Subject: Collin County Healthcare Facility, Parking Garage, and Medical Examiners
Revised PCO No. 062; RFI #208 ME Loading Dock Wall Detail Clarification

Issue No. 062 - RFI 208 ME Loading Dock Wall Detail Clarification Amount

RFI #208: ME - Loading Dock Wall Detail Clarification

2 TYPICAL SECTION AT LOADING DOCK WALL
3/4" = 1'-0"

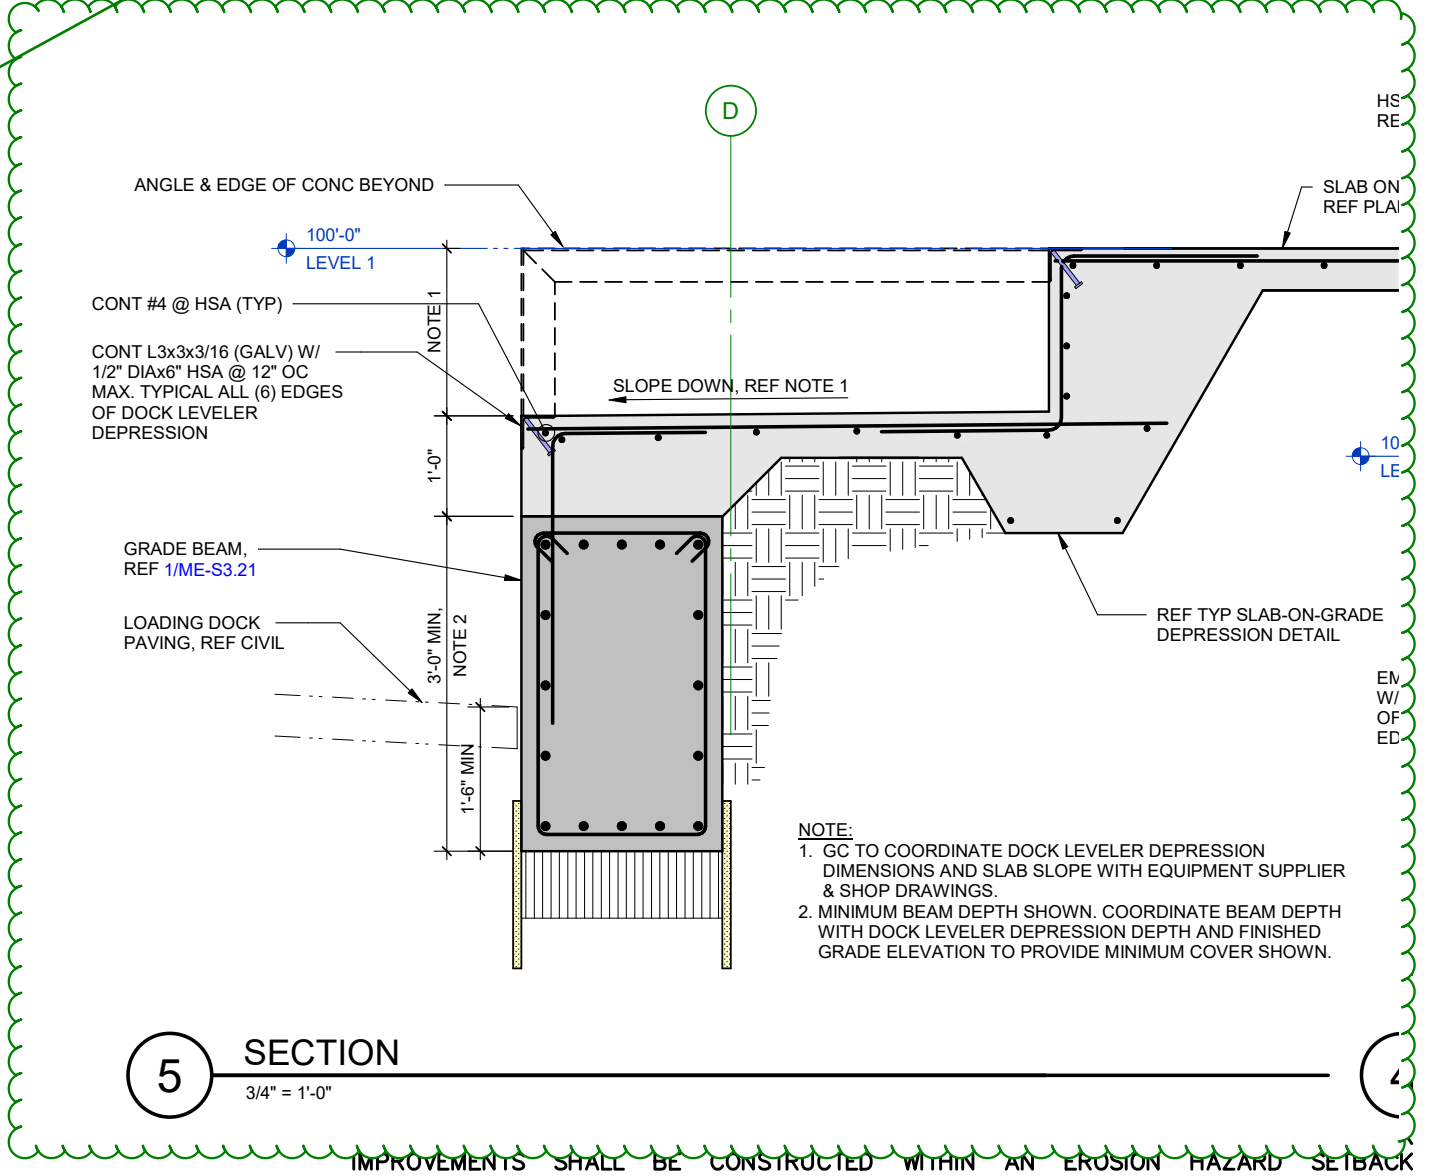
Q3.) Please clarify the perforated drain pipe scope of work. Does this pipe extend parallel to the entire stretch of the loading dock retaining wall?

Q3. PER 2/ME-S3.01, PERFORATED DRAIN PIPE AND CONNECTION TO TRENCH DRAIN PER CIVIL.

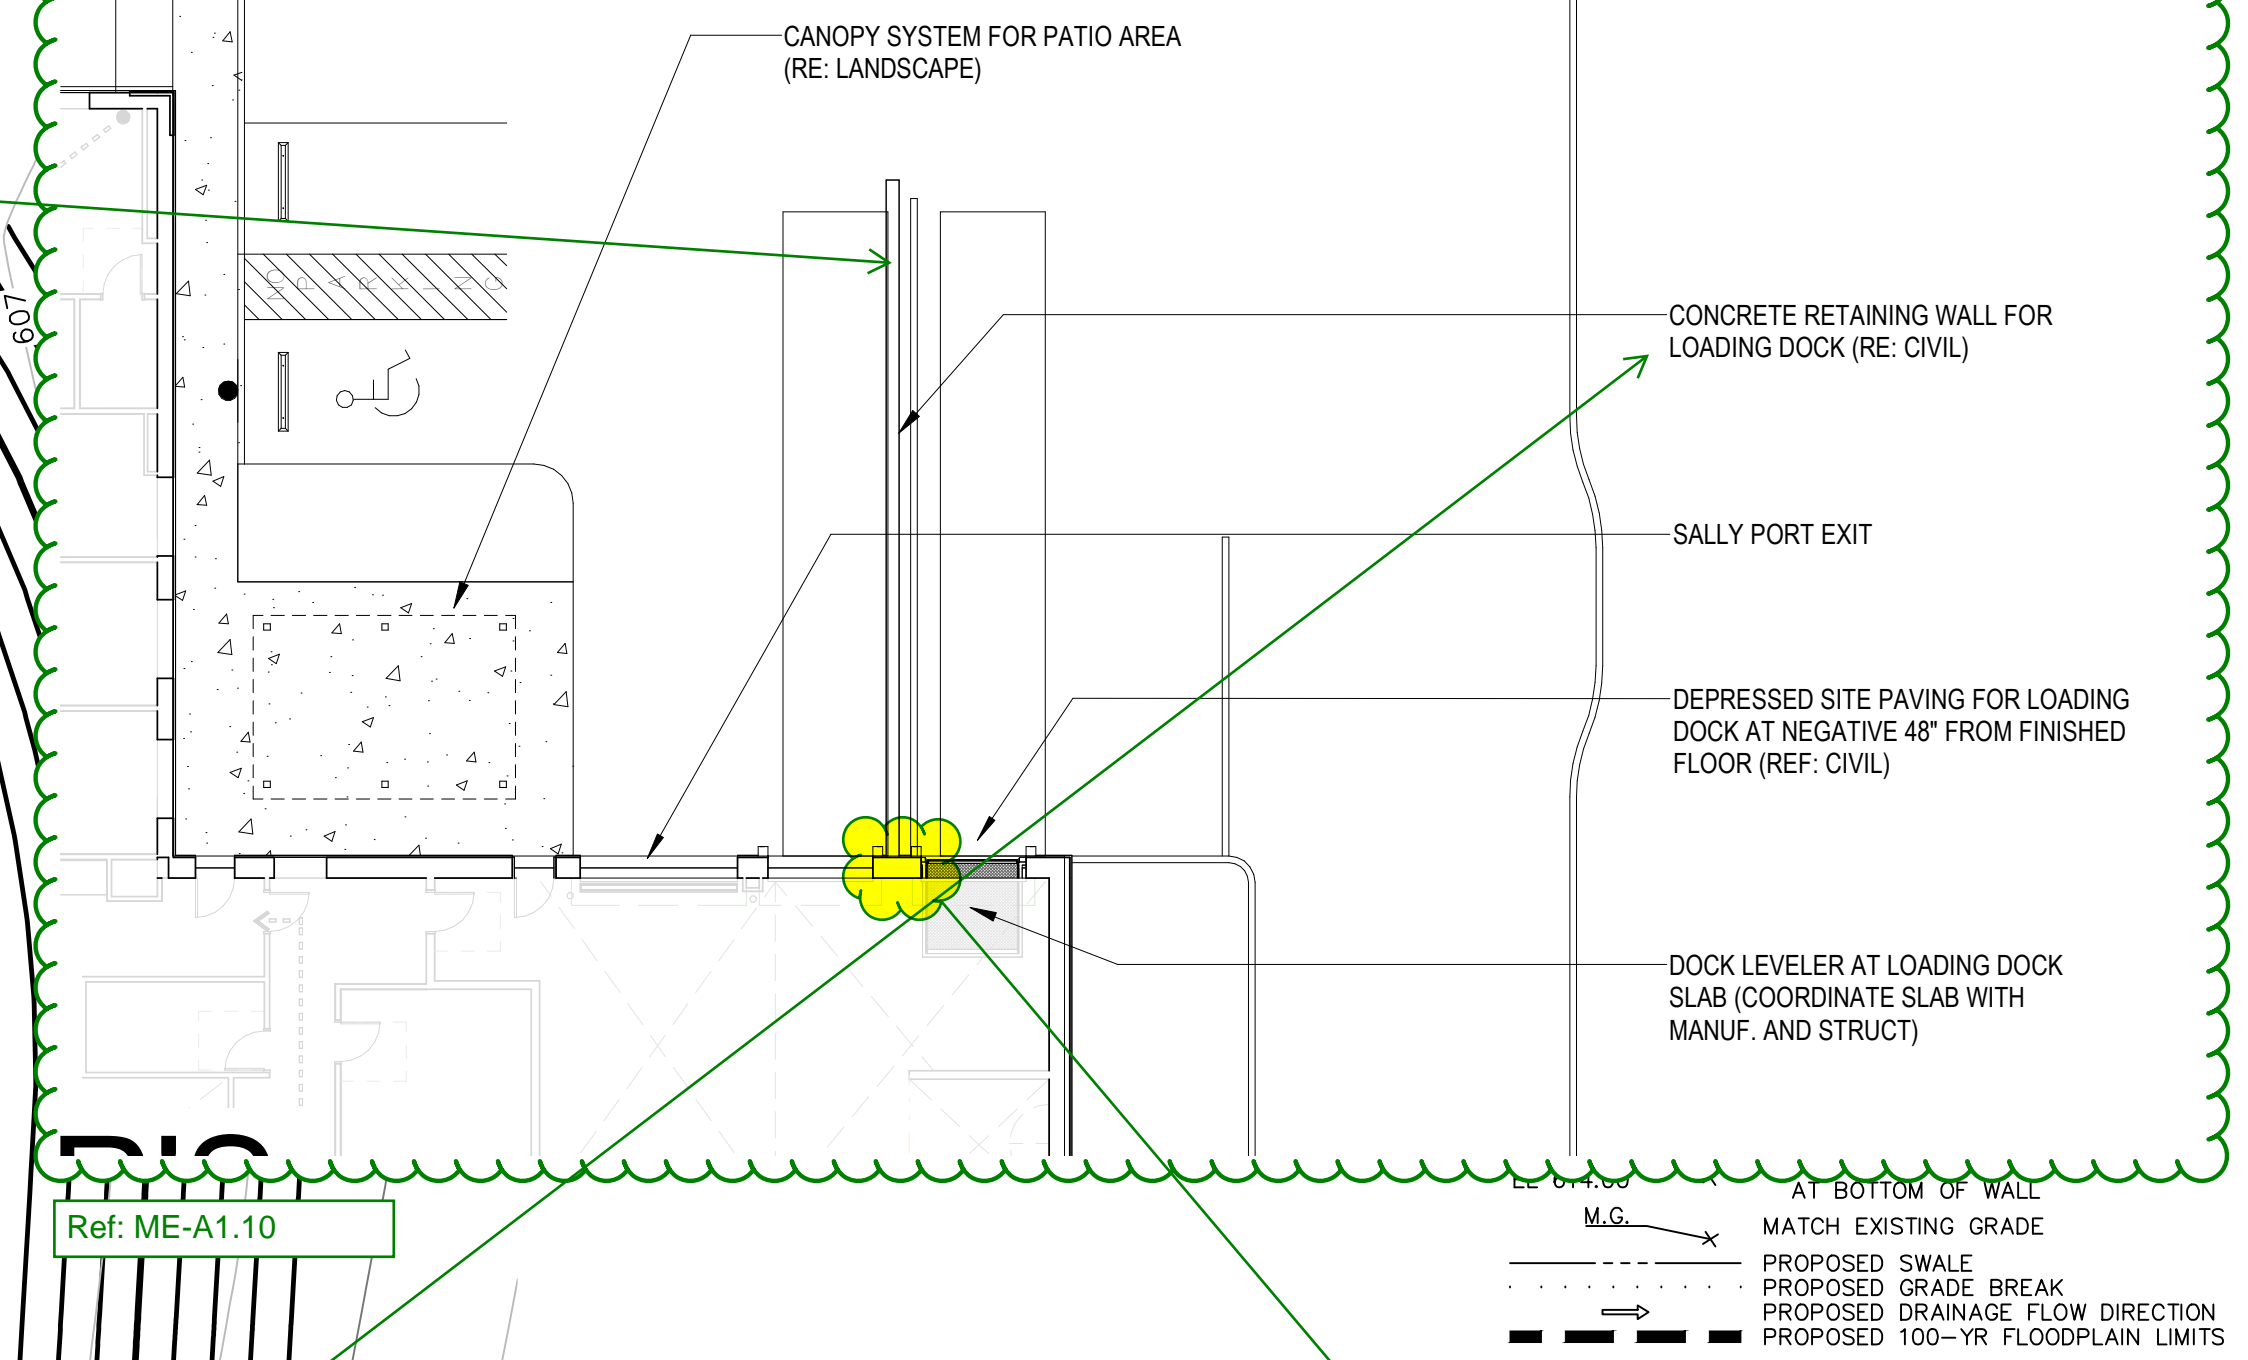
Q1.) Please provide a trench drain inlet detail/section cut. Structural sheets details to reference Civil. We could not find a civil detail for this trench drain

Q2.) Are there supposed to be two walls? The architectural site plan does not specifically call out a second wall

Q4.) Please clarify/confirm the retaining wall dimensions i.e. height, total length etc.

Q5.) Please clarify the retaining wall expansion detail i.e. wall to building.
How does this retaining wall interact with the structure? Please keep in mind the interaction between the facade and concrete retaining wall.

Q6.) What is the centerline of this retaining wall? Please provide a dimensional layout.

1. Trench detail included in update storm detail sheet.
2. Yes, there are two walls. Please see updated grading plan.
3. Updated storm plan includes information regarding Structural's drain detail. Wall penetration should be 2" above the finished grade of the trench rather than below grade and will surface drain to the trench.
7. Please see updated grading plan. Curb has been added around landscaping island.
9. Grading has been updated. Please see attached.
10. Please see updated grading plan.

Q5. STRUCTURALLY, EXPANSION JOINT IS REQUIRED BETWEEN THE BUILDING AND THE RETAINING WALL.

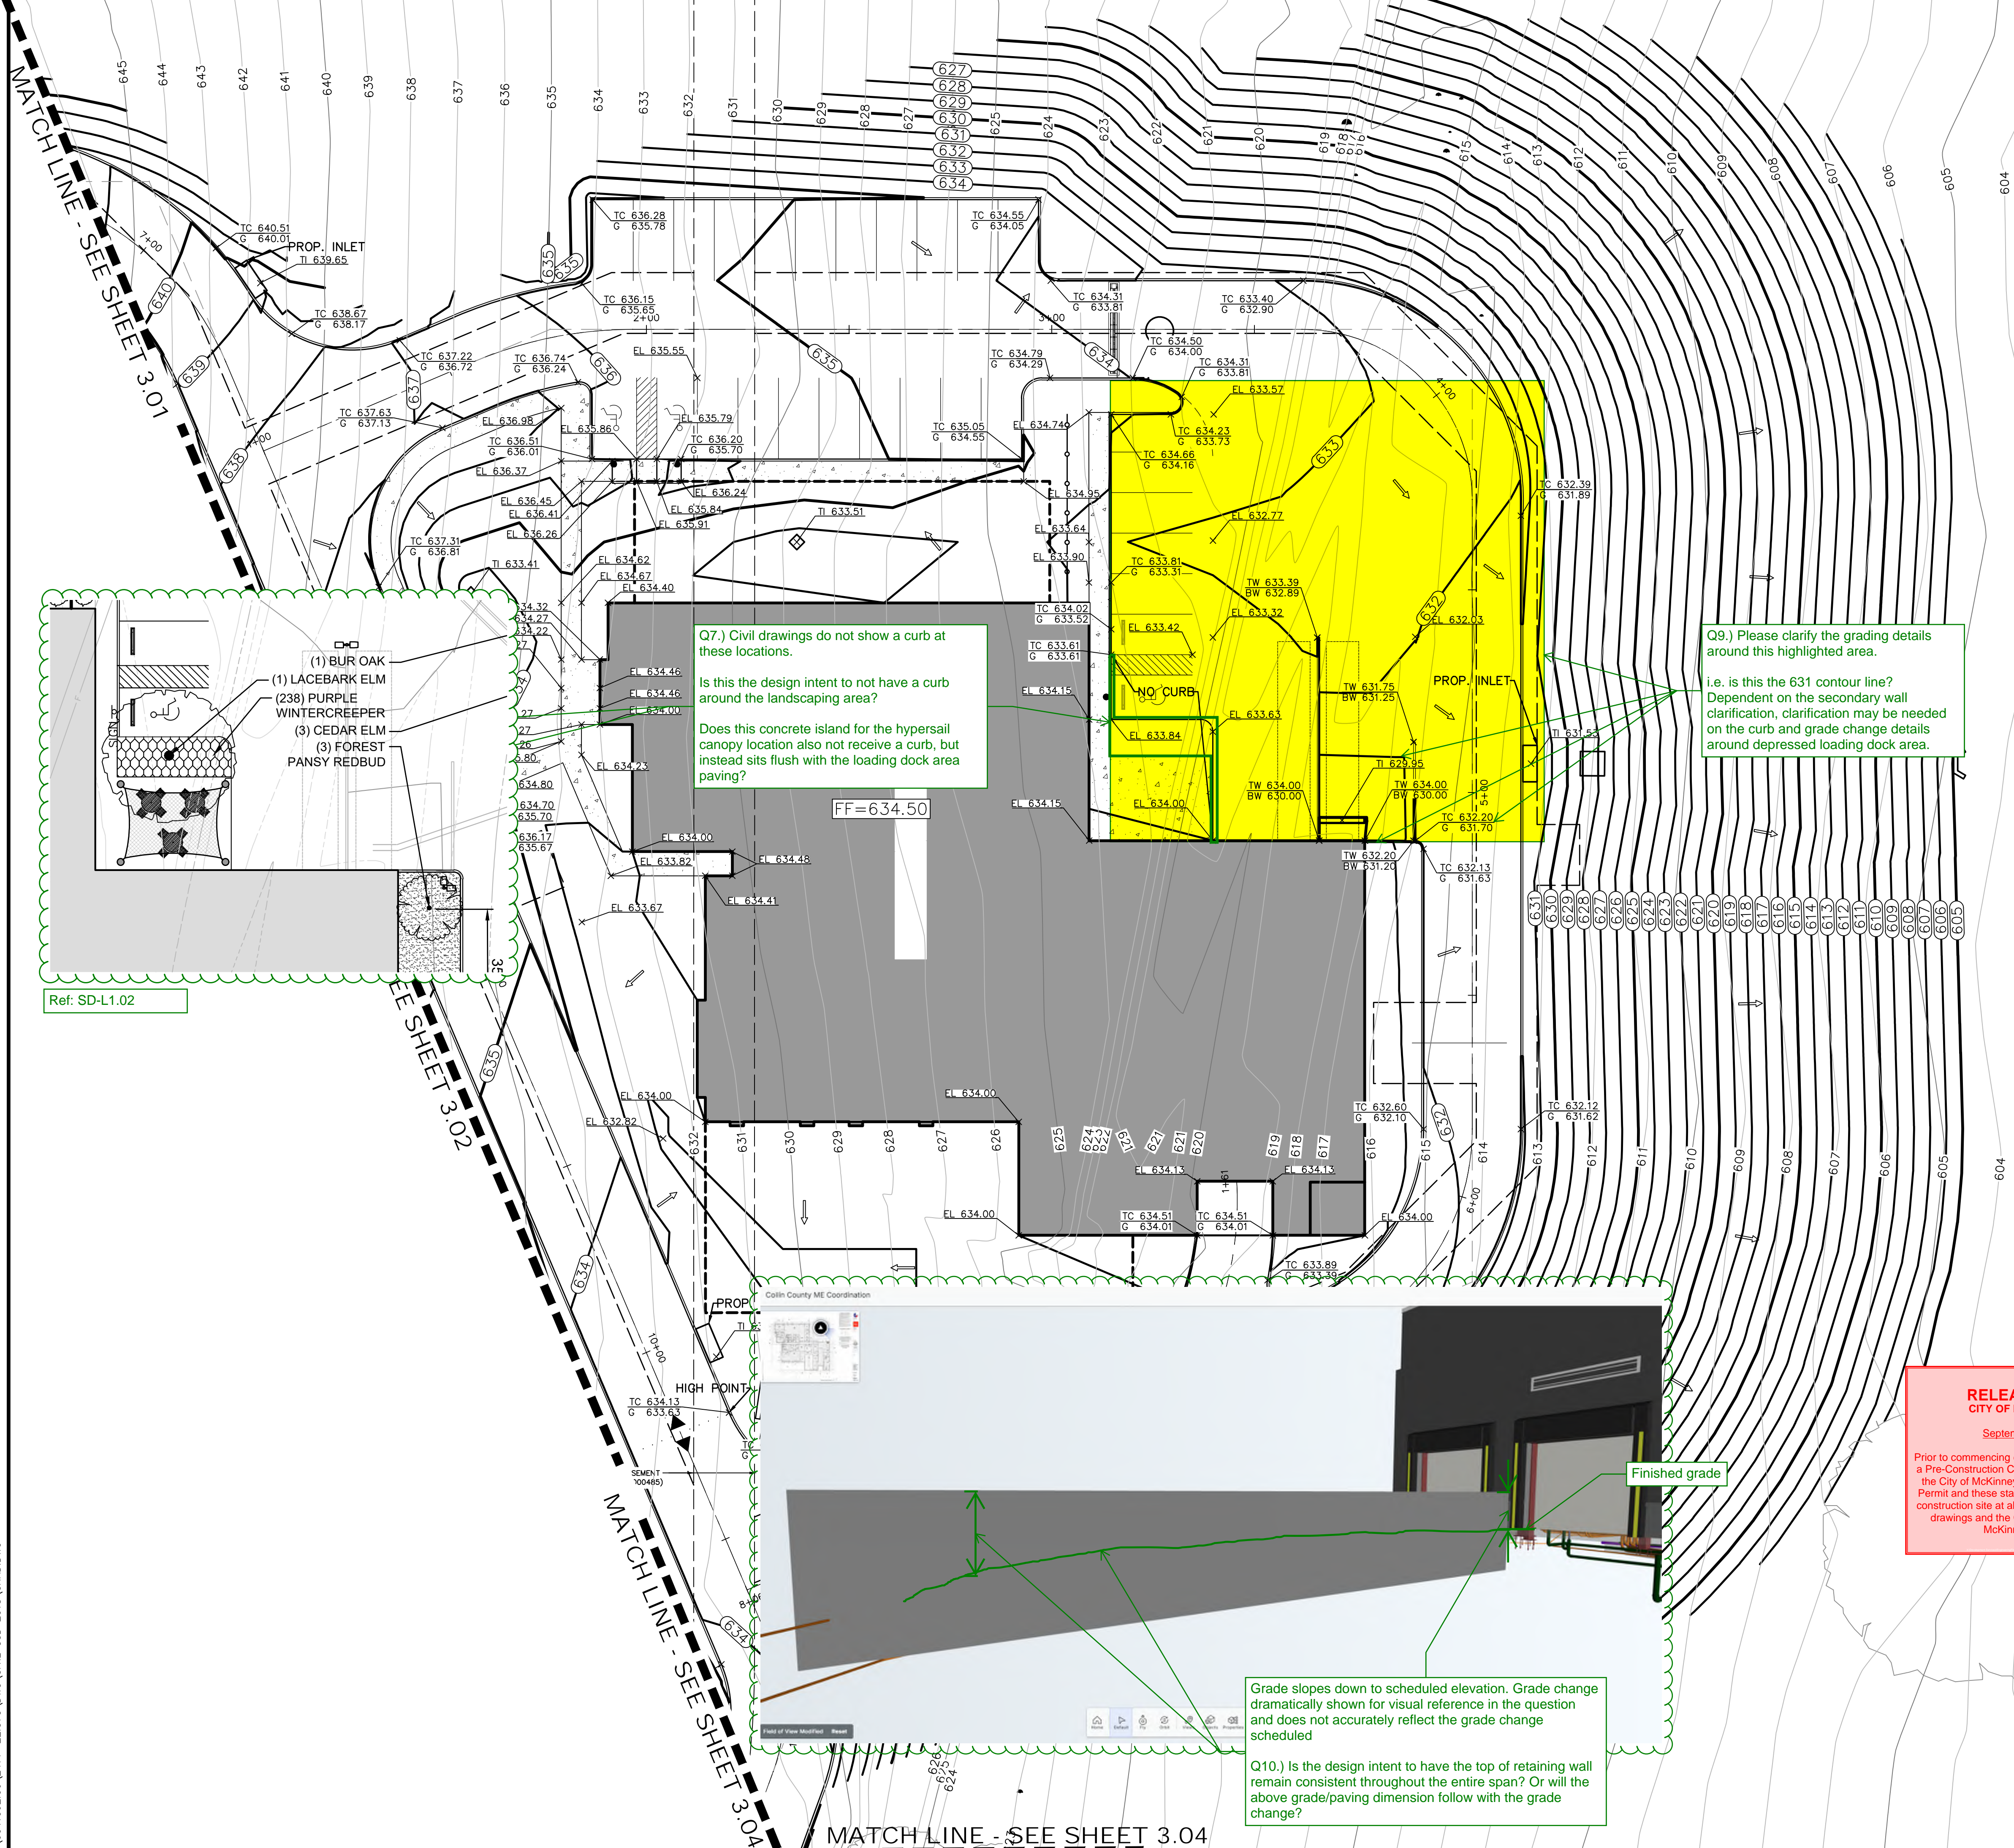
Q7.) Civil drawings do not show a curb at these locations.
Is this the design intent to not have a curb around the landscaping area?
Does this concrete island for the hypersail canopy location also not receive a curb, but instead sits flush with the loading dock area paving?

Q9.) Please clarify the grading details around this highlighted area.
i.e. is this the 631 contour line? Dependent on the secondary wall clarification, clarification may be needed on the curb and grade change details around depressed loading dock area.

Grade slopes down to scheduled elevation. Grade change dramatically shown for visual reference in the question and does not accurately reflect the grade change scheduled.
Q10.) Is the design intent to have the top of retaining wall remain consistent throughout the entire span? Or will the above grade/paving dimension follow with the grade change?
